**PLANNING & ZONING BOARD
AGENDA ITEM 7A**

TOPIC: Lyngblomsten at Lino Lakes Second Addition
PUD Final Plan/Final Plat

CASE NUMBER: PZC2026-0008

Memorandum

SITE PLAN

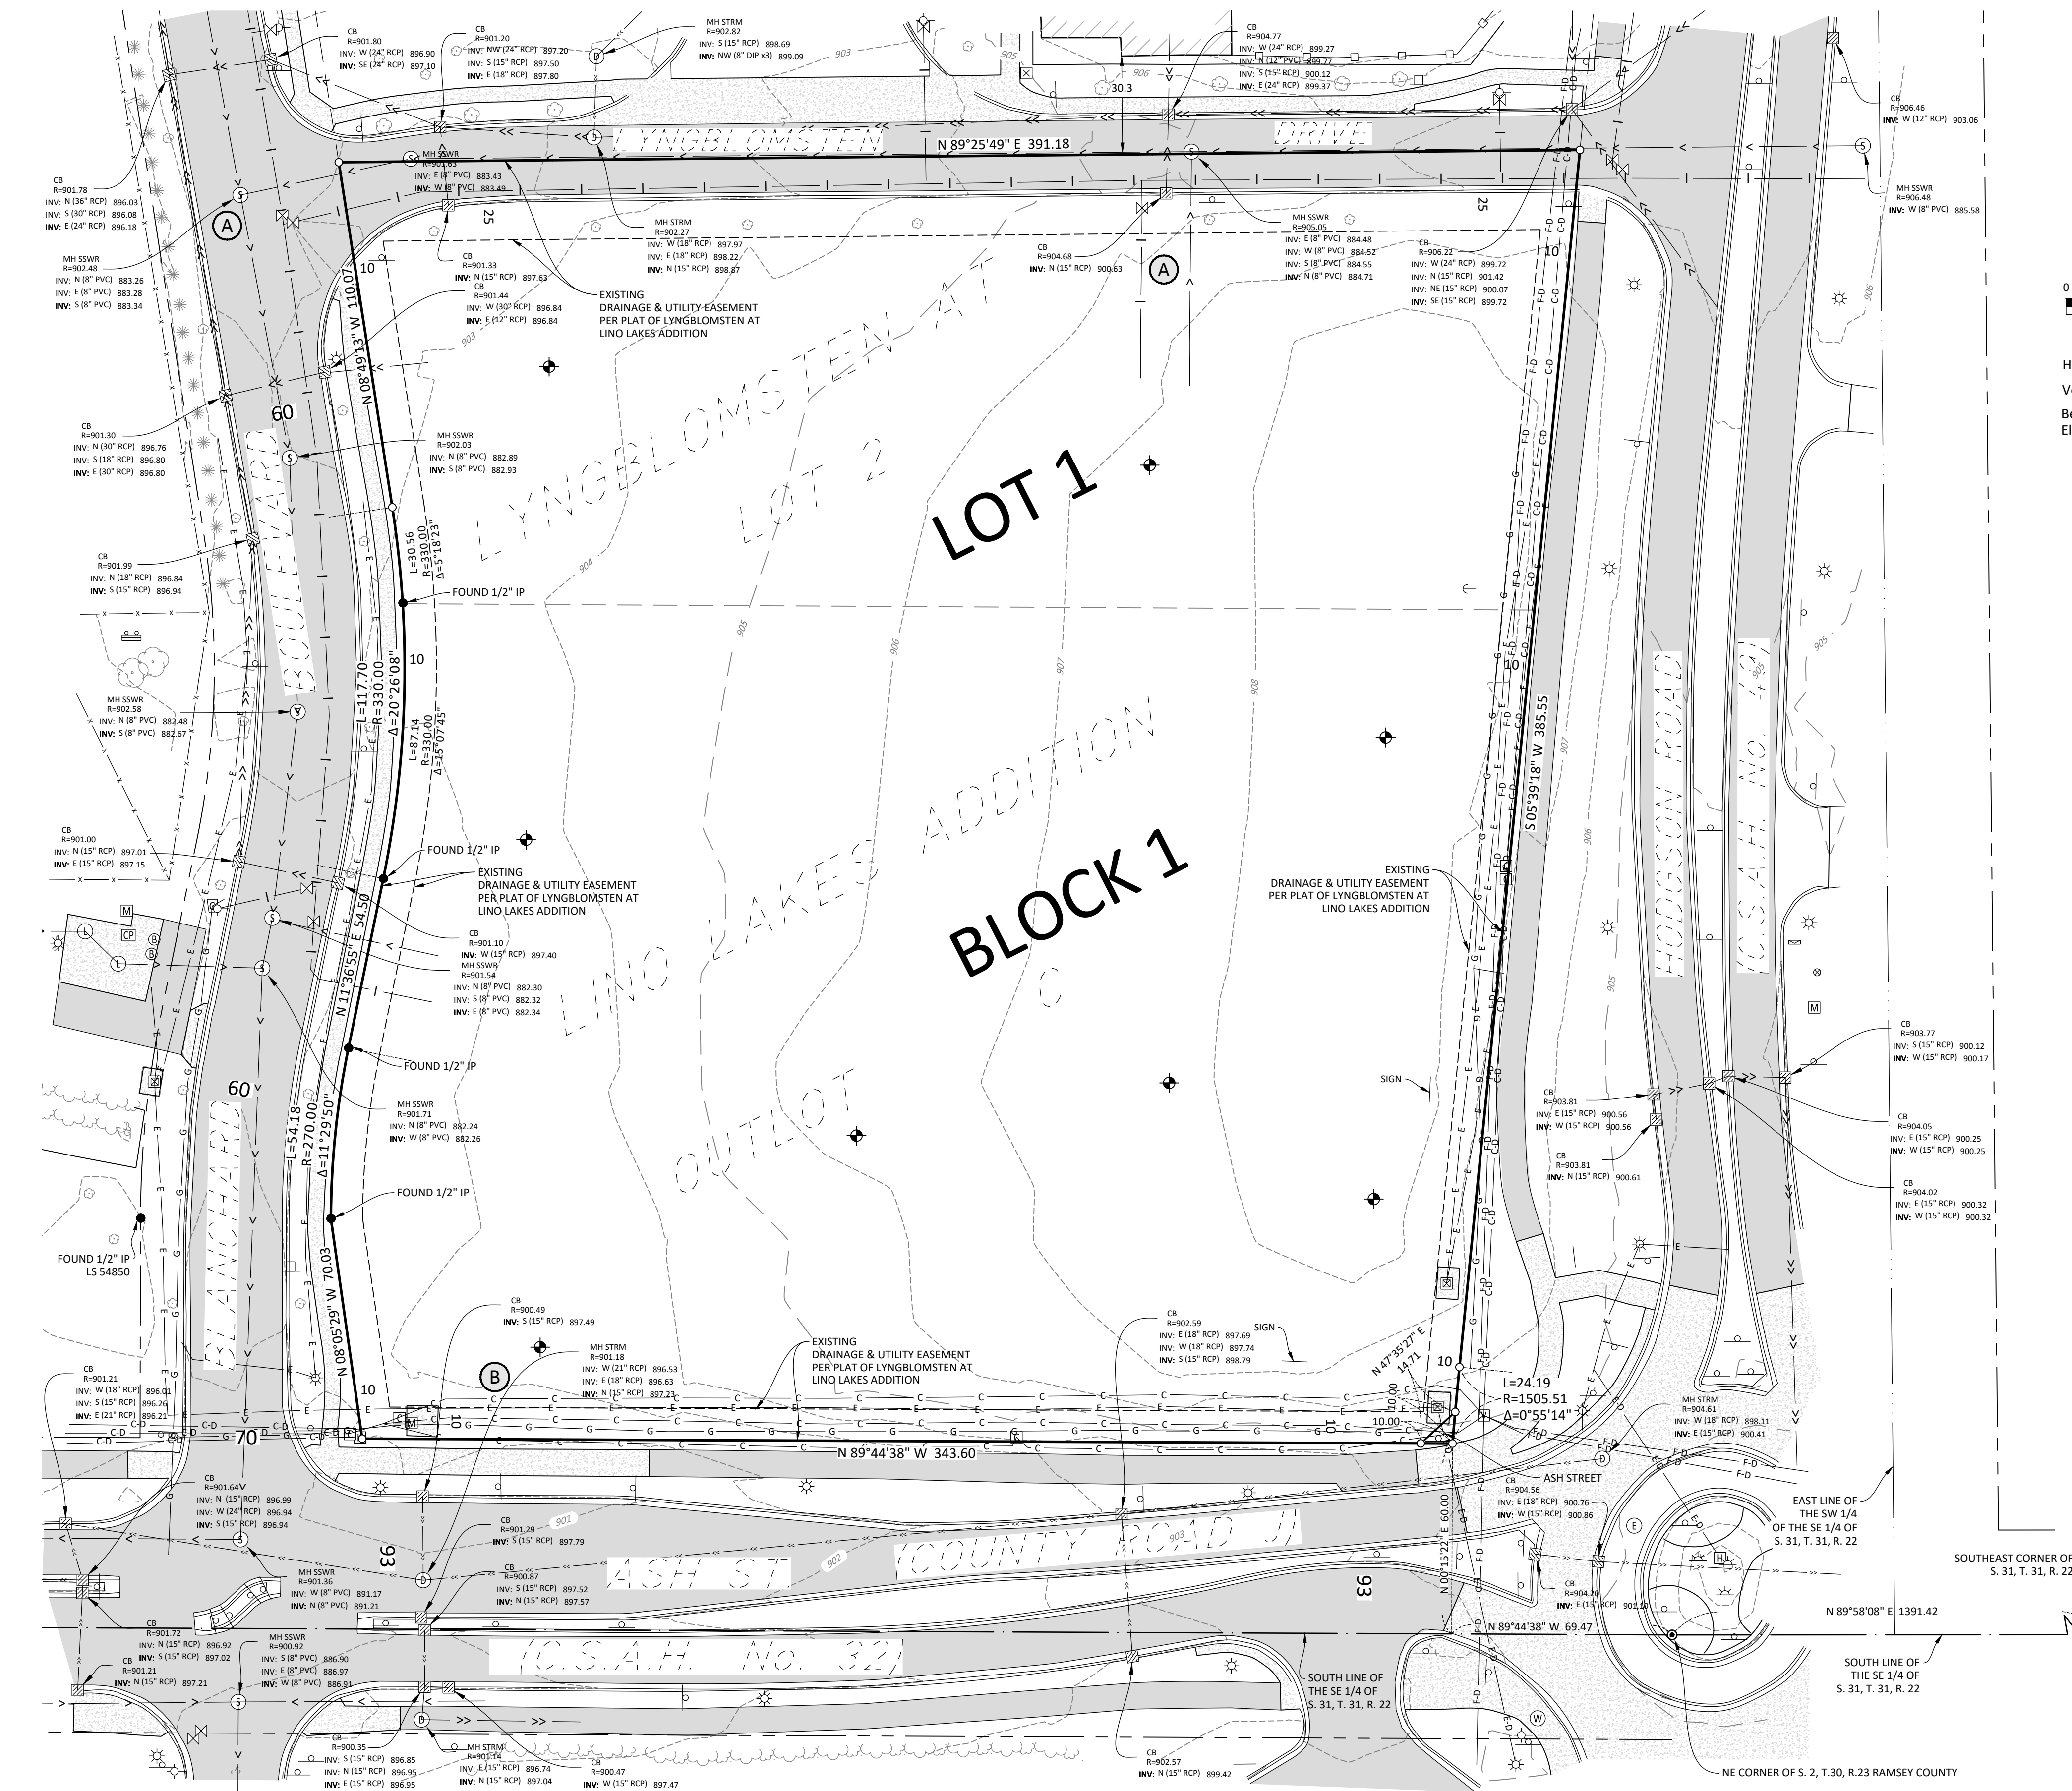
8. The original site plan Sheet C1.22, Site Plan South dated 3/9/26 showed storage areas in the east side of retail units.
 - a. Storage areas and materials shall not be visible from the outside.

1. For example, Sheet C1.20, Site Plan Overall clearly shows them marked but Sheet C1.22, Site Plan South does not.
 - b. Preliminary Plat, Sheet 1 of 1:

- i. Show the proposed daycare rooms, outdoor play areas, 5 retail suites etc. as it was approved by City Council on May 11, 2026.
 - ii. This applies to all applicable plan sheets.

LANDSCAPE PLAN SOUTH

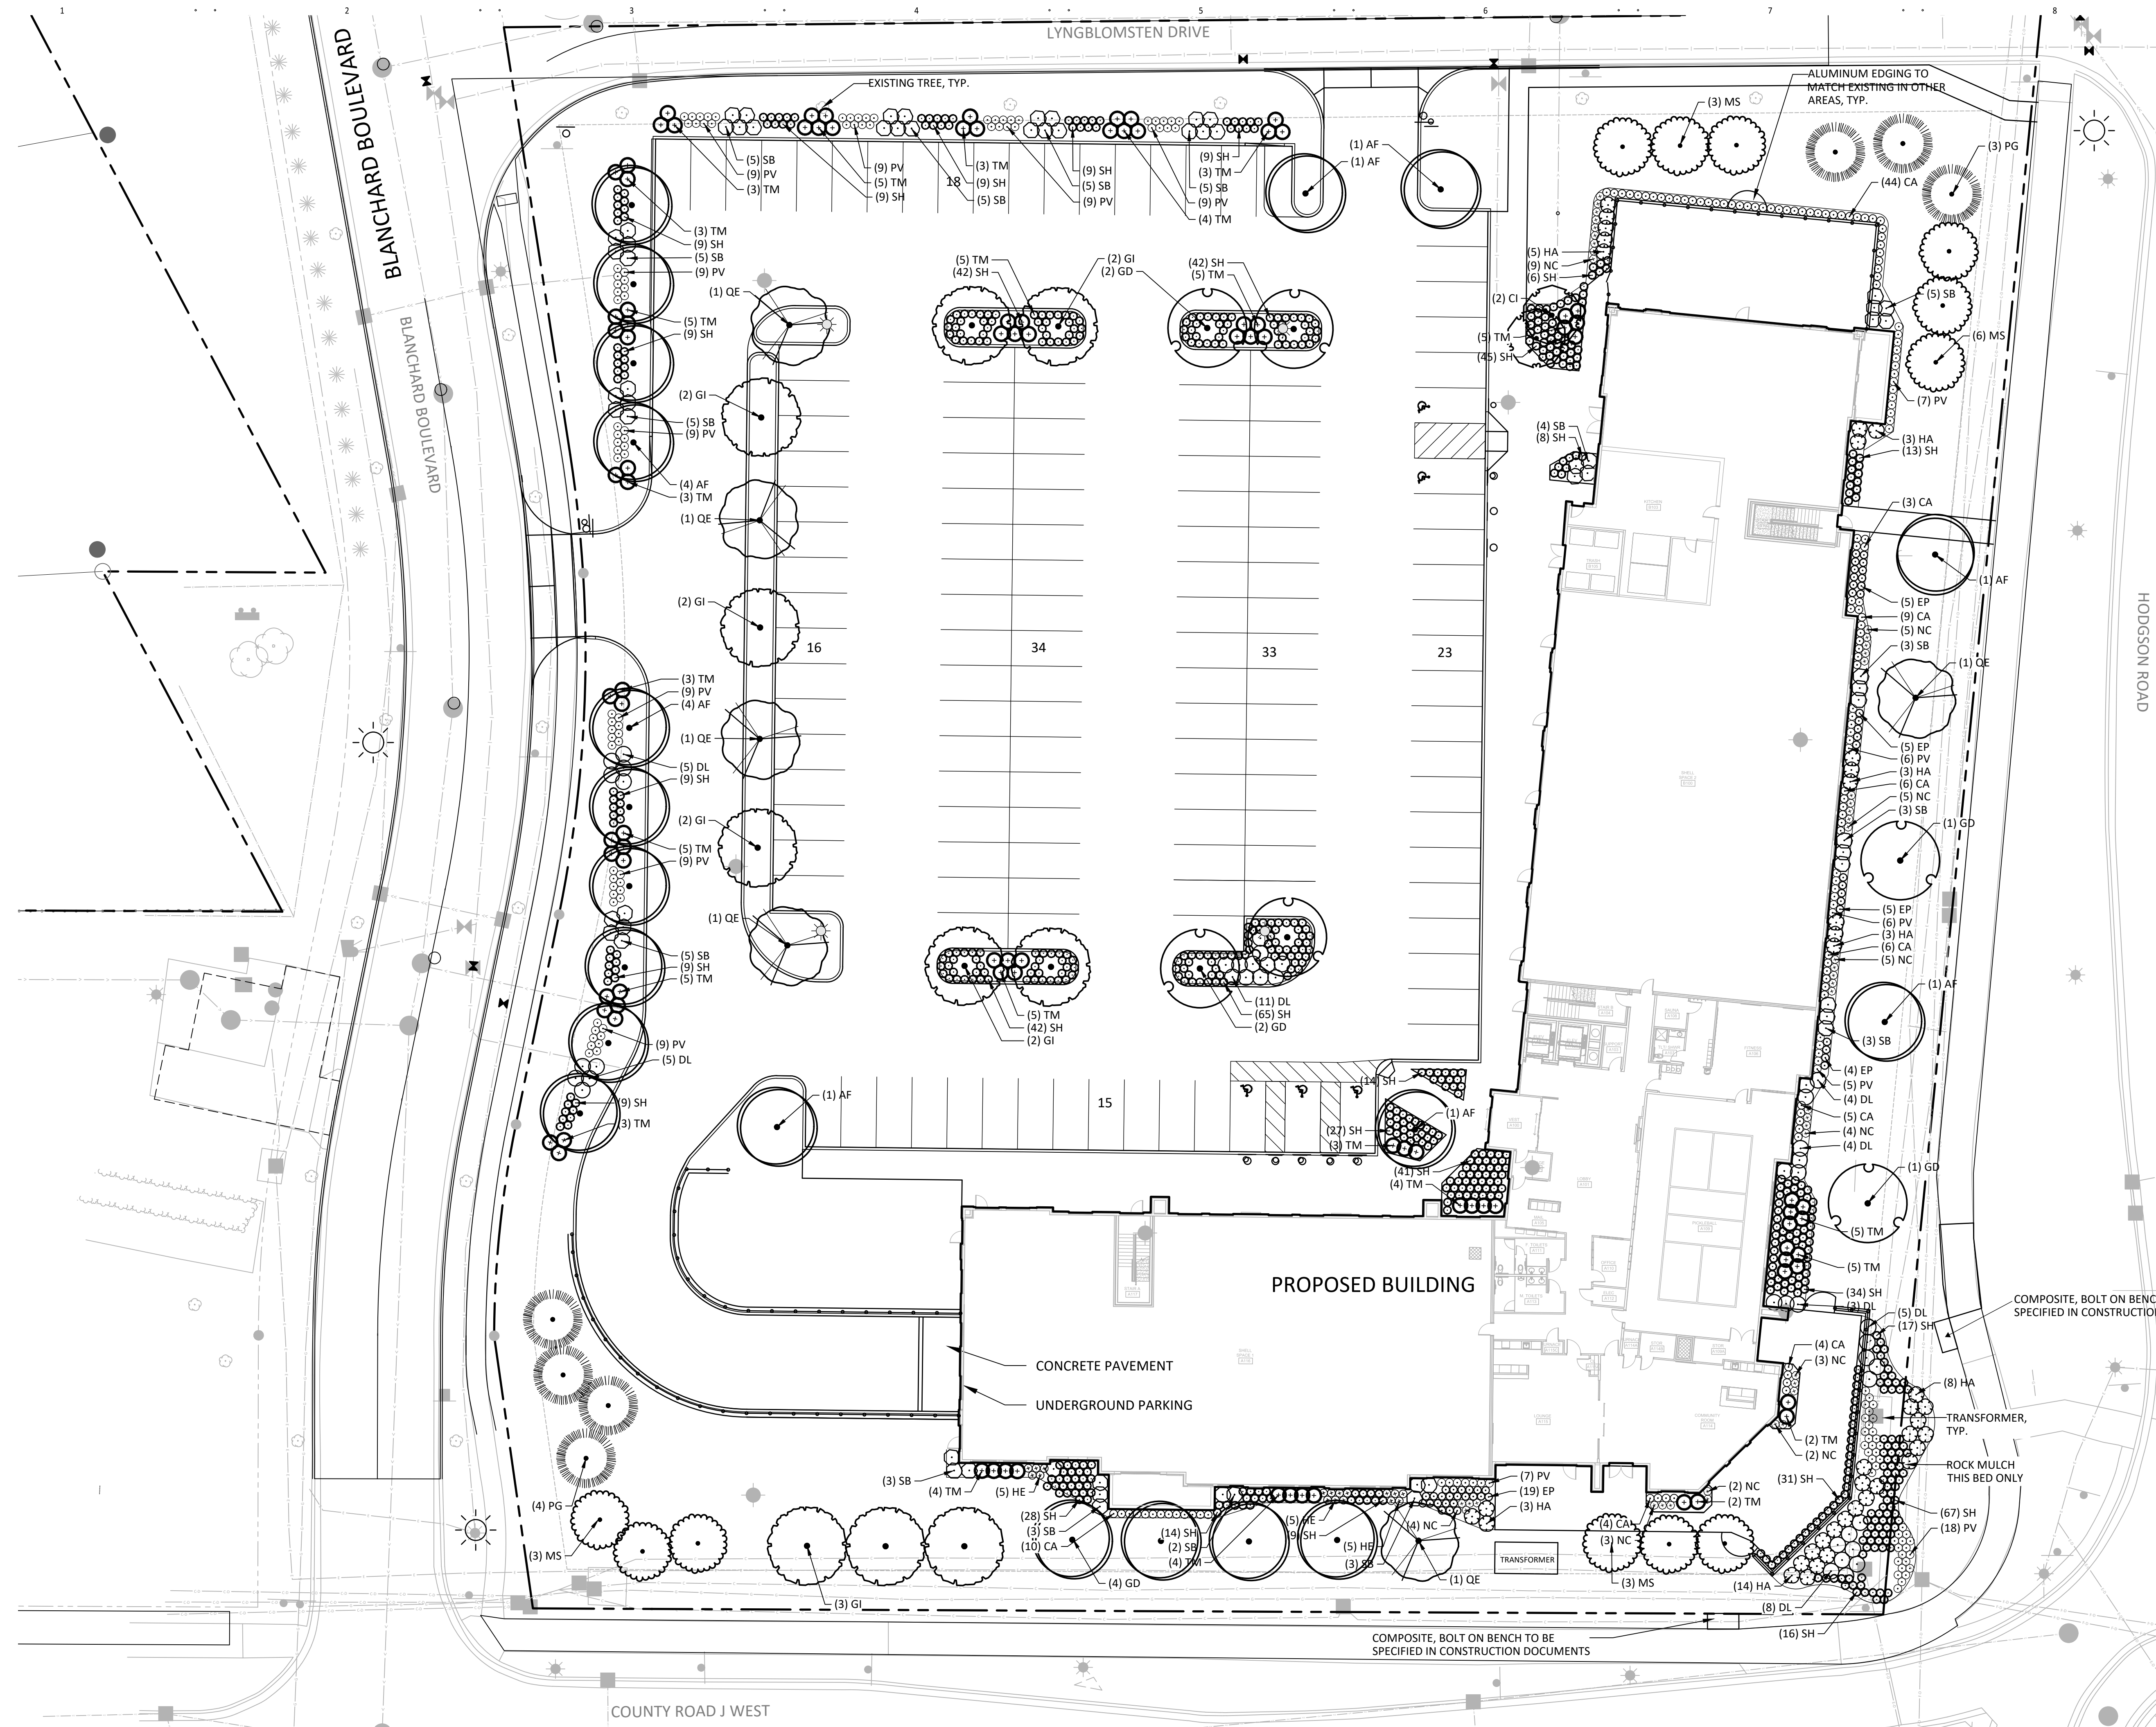
- d. Sheet L1.02, Landscape Plan South:
 - i. The transformer along CR J shall be screened.
10. Lyngblomsten Lino Lakes Campus-City Submittal-Final PUD (Amendment 4) dated 6/08/2026:

1. New easements shall be dedicated on this plat.
 - d. Sheet L1.01, Landscape Plan South:
 - i. The transformer along CR J shall be screened.

1. 30" screening is required adjacent to parking lots to public right of way. Screening should be provided on the north side of the parking lot adjacent to Lyngblomsten Drive.

2. Provide tree protection fencing and detail in the plan set for existing boulevard trees to be protected during construction.
3. Update canopy coverage calculations. My calculations show 11 trees receiving 50% credit for an additional 1,200 SF. Potentially 1 tree is within 7-12 and would receive 25 percent credit.

4. Recommend adding one additional tree along the Hodgson Road boulevard. Currently the proposal shows trees throughout the building breaking up the frontage. There is one gap of trees between the stairs and the restaurant that doesn't seem to blend into the overall design.

5. Confirm irrigation reuse area and provide final calculations for reuse.
6. Recommend matching curb to the rest of the development.
7. All landscaping should be removed from the Anoka County Right of Way unless an agreement and documentation is provided with the county approving the work.

8. The bench needs to move out of the ROW unless permitted by the County.
9. Tree species are required to be less than 30% of a genus to prevent widespread disease and promote diversity. Currently 47% of the trees are within the genus Acer. Add additional species to reduce the amount of maples
